**MEMORIAL UNIVERSITY OF NEWFOUNDLAND**

**NETWORK AND FIREWALL UPGRADE , CENTRE FOR ANALYTICS,**

**#RFP-001-26**

**ADDENDUM #1**

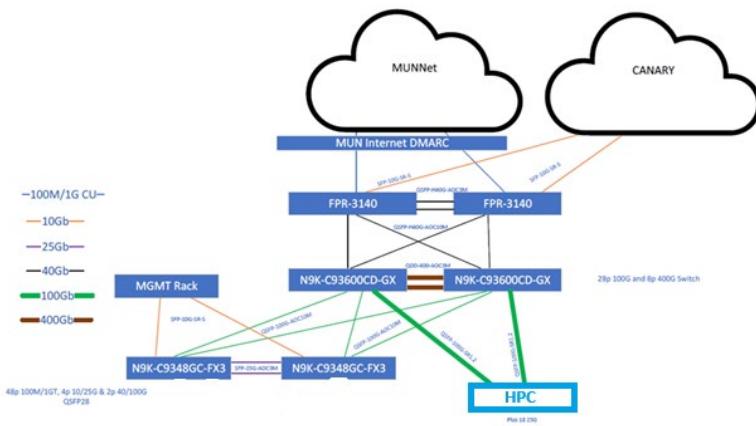
1) The BOM includes four Cisco Nexus devices. Could you please confirm whether these are intended to replace existing switches or be deployed in addition to the current infrastructure, and their intended role in the target architecture (e.g., core, aggregation, leaf, spine)?

2) As the RFP requires compatibility with the existing environment, are there any high-level diagrams or architectural overviews available to support integration planning?

Answer: Two will be new, and two are replacements. (see diagram below)

Answer: Current Architecture has one firewall to 2 x N9K switches. The N9K-C936000CD-GX layer is new and the FX3 switches are replacement.
